# Updates to the Rhode Island Statewide Total Maximum Daily Load (TMDL) for Bacteria Impaired Waters

**Final Report  
September 2023**

## **Section 6.0 Response to Comments Received During the Public Comment Period**

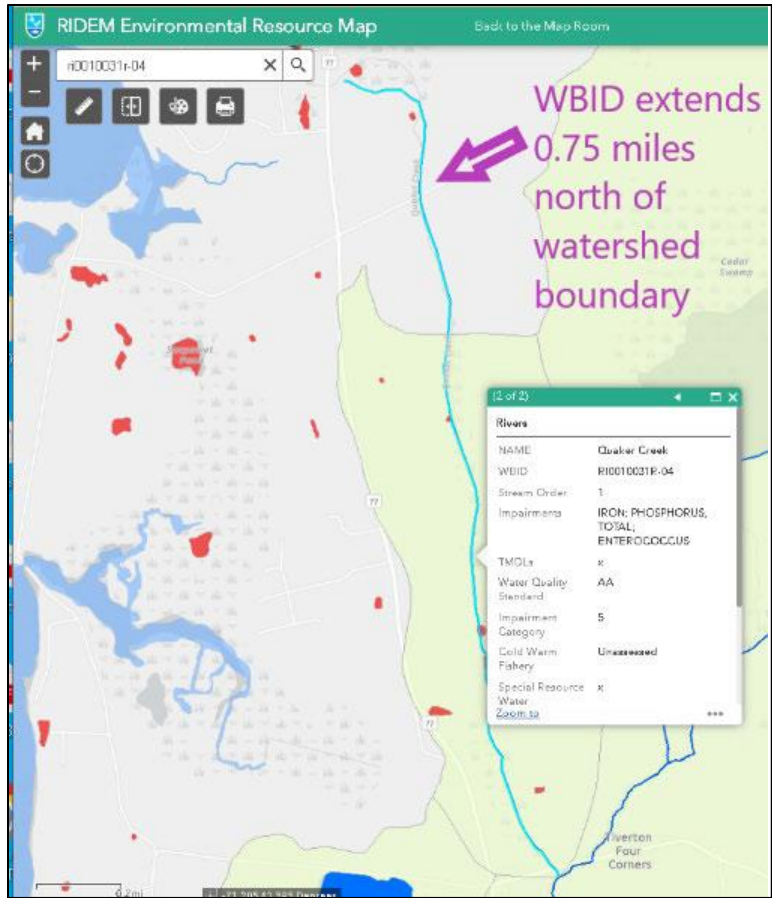
**17. Landfill contributions should have its own section under "Exceedances and Potential Sources."** According to the TMDL documentation for the City of Newport Reservoirs (RIDEM, 2021), "The landfill swale is a stormwater conveyance to Quaker Creek and is therefore considered to be a point source to a water of the state." Additionally, "the landfill swale was documented to convey leachate containing TSS, ammonia, and dissolved organic carbon (DOC) during dry weather. Stormwater runoff from the upper portions of the landfill during wet weather is elevated in TSS, total phosphorus, total nitrogen (primarily as ammonia), DOC, and Enterococci. Actions to mitigate this point source should be addressed explicitly within this documentation.

The Tiverton Landfill is currently undergoing the final closure and capping process within the licensing program of RIDEM's Office of Land Revitalization and Materials Management. It is expected that the process will be complete by September 2023. The RIPDES permit is expected to be issued following the completion of the closure and capping. The final closure and capping of the landfill will manage any stormwater or other discharges from the landfill that could impact Quaker Creek. No changes have been made to the document.
